SUBJECT : ImageQuest Co., Ltd.
FCC ID: PJIL17A0D080
Class II Permissive Change
Orig. Grant Date: March 12, 2003

Transmitted herewith, on behalf of ImageQuest Co., Ltd. is an application for a Class II Permissive Change Certification of the following 17-inch LCD Monitor:

FCC ID : PJIL17A0D080
Model/Type : L70S/L17A0D080

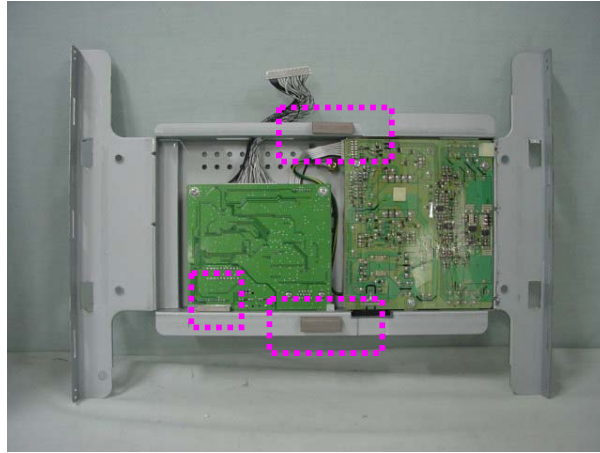
1. Attach a gasket on the main frame and main board to contact the lcd panel

2. Apply ferrite core to OSD signal line
